**SEQUOYAH FUELS CORPORATION
RESPONSE TO REQUEST FOR
ADDITIONAL INFORMATION
GROUND WATER CORRECTIVE
ACTION PLAN REVIEW**

Subject: Sequoyah Fuels Corporation, Docket – 40-8027
Request for Additional Information – Groundwater Corrective
Action Plan (TAC L52528)

Responses to NRC RAIs of September 28, 2005
Ground Water CAP Review

TITLE: Surface Water Users Permitted Stream Water Diversions	
PREPARED BY: SCM	FILENAME: SurfWtrUsers.dwg
REVIEWED BY: CLH	FIGURE NO. 1
DATE: 29 Nov 2005

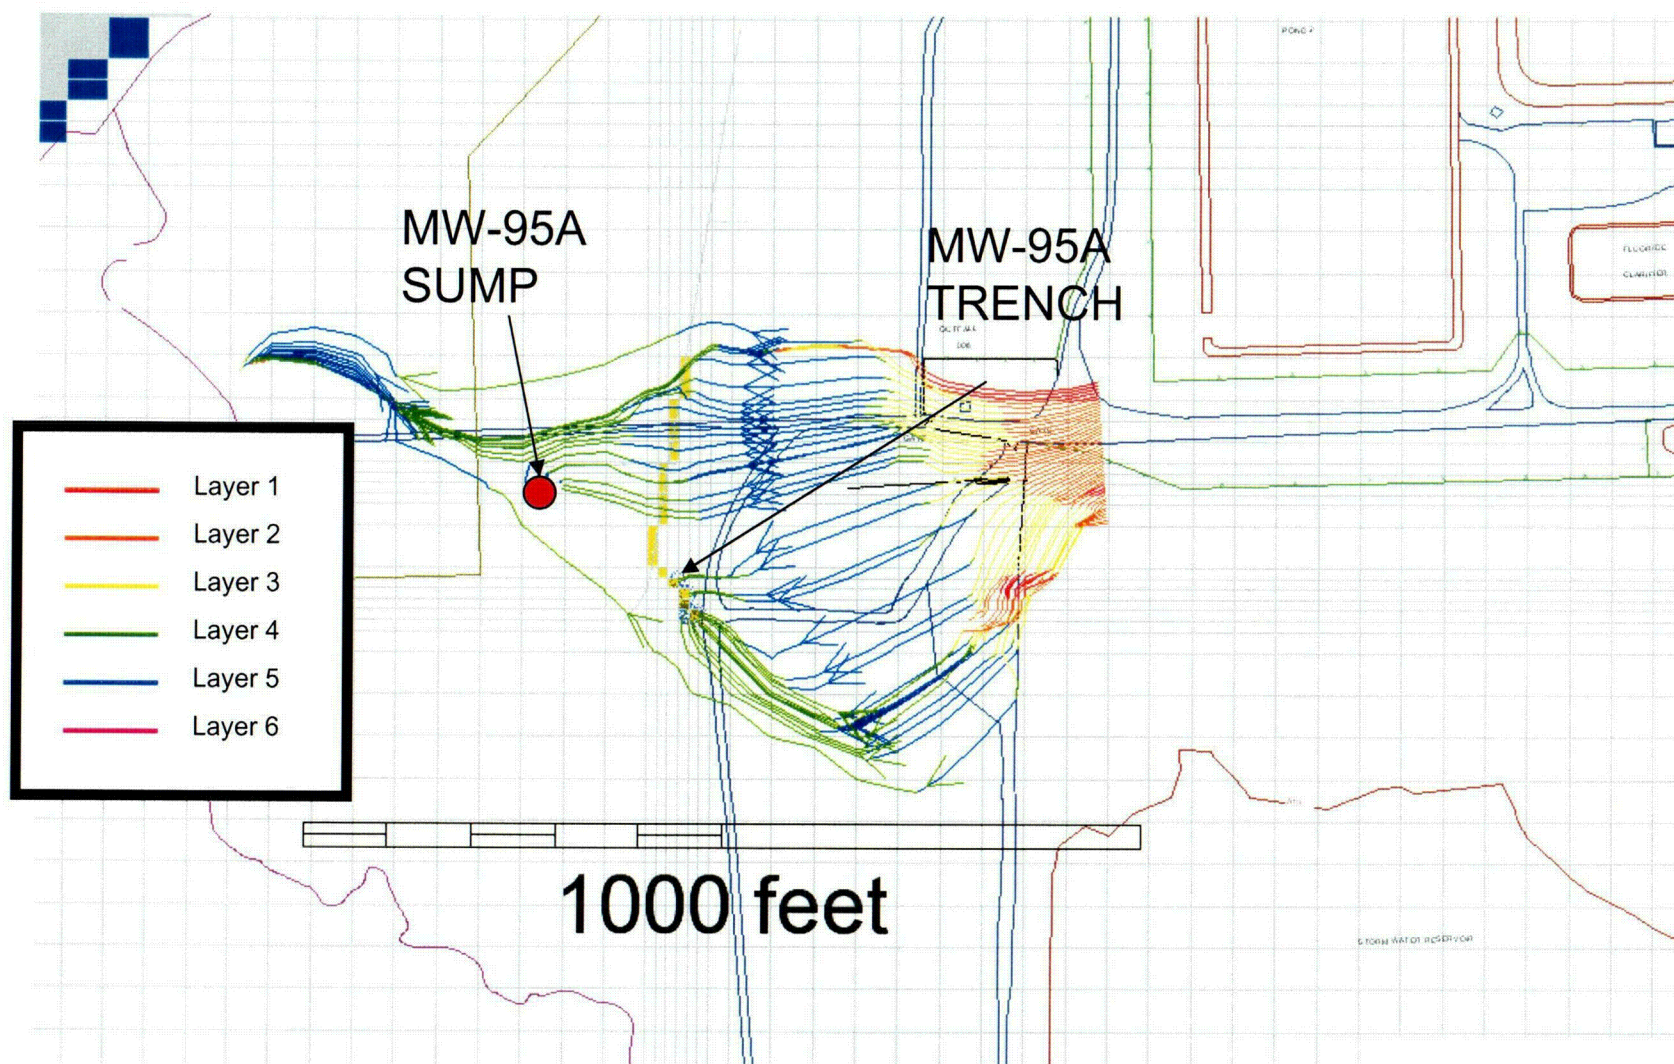
- A. SFC should identify ground-water users within 2 miles of the site boundary and surface water users within 2 miles downstream of the site. This information is necessary to allow NRC staff to assess impacts of proposed remediation strategies on potential ground-water and surface water users. NRC staff will also use this information to determine if the proposed strategies will be protective of human health, safety, and the environment.

OWRB found two permitted stream water diversions within 2 miles downstream of the Facility. Both are used for irrigation purposes. A copy of the response from OWRB and a map showing the location of the two permitted stream diversions are included in Attachment CAP2A-1.

**MODELED DRAWDOWN
FOR PROPOSED CAP WELLS**

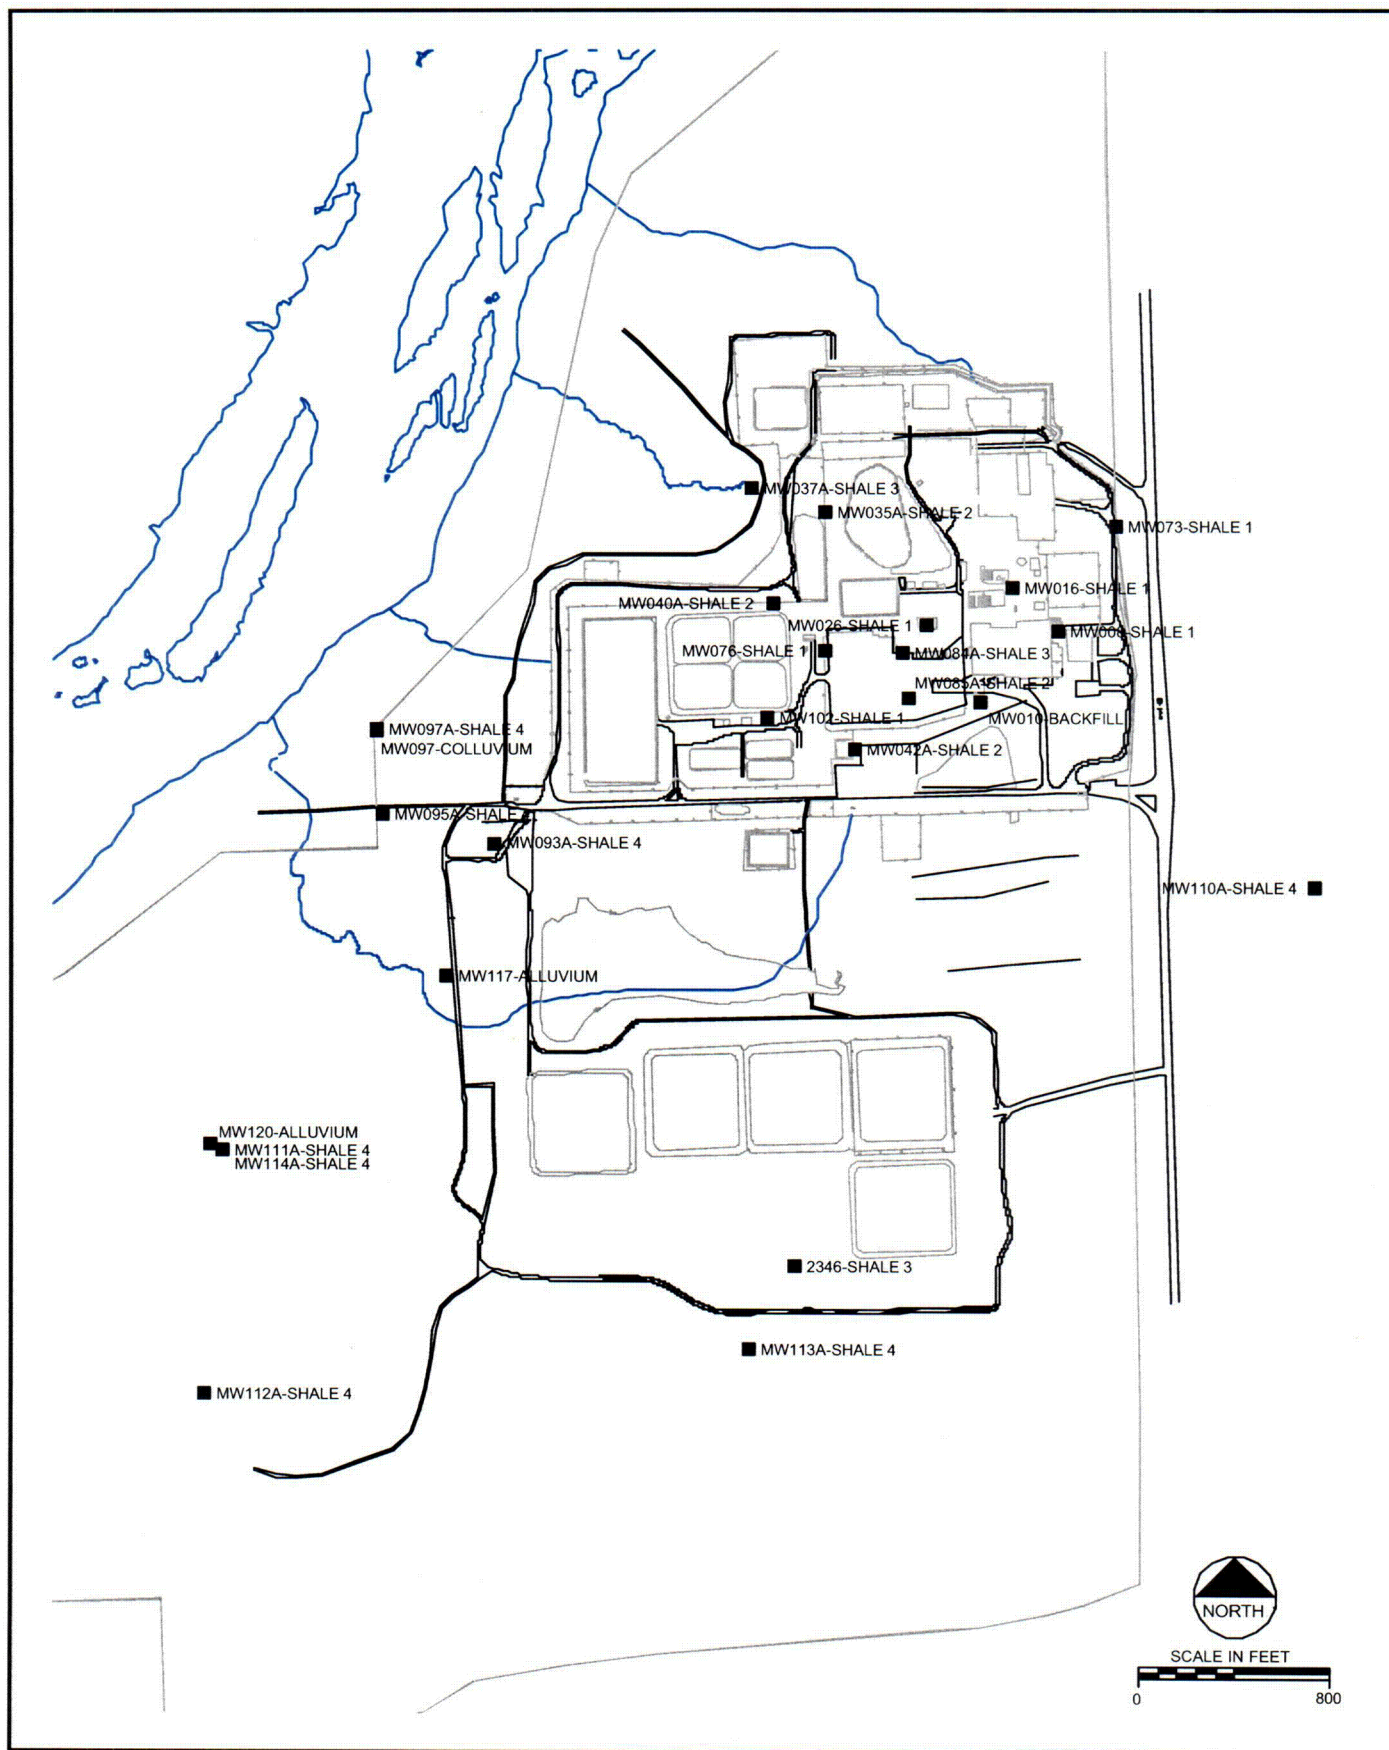
- A. SFC's March 14, 2005, response to NRC's December 6, 2004, RAI provides information regarding the installation of proposed extraction wells in the northwest portion of the site, as part of the CAP. Locations and descriptions of these wells should be included in the main CAP text, so the complete remediation is described in the main document. In addition to the well locations, effects of pumping on the terrace ground-water system potentiometric surface, estimates of the capture zone, and expected pollutant yields should be provided in the CAP. Understanding these aspects of the extraction wells will allow NRC staff to evaluate whether or not the wells will remediate ground water effectively.

The proposed wells are located as shown in Figure 2 of the revised Transport Modeling Memo dated March 7, 2005 and submitted with the responses to the first round of RAIs. These two wells were proposed to accelerate collection of ground water contaminants uranium in the northwest portion of the site as illustrated in Figure 2. These wells would each consist of 8 inch diameter schedule 80 PVC with 0.010 inch machine slotted screens and appropriate clean silicate sand filter pack and surface seal and screened in Shale unit 4. The wells would be pumped with a low volume pump or with a small submersible pump. Based on the estimated
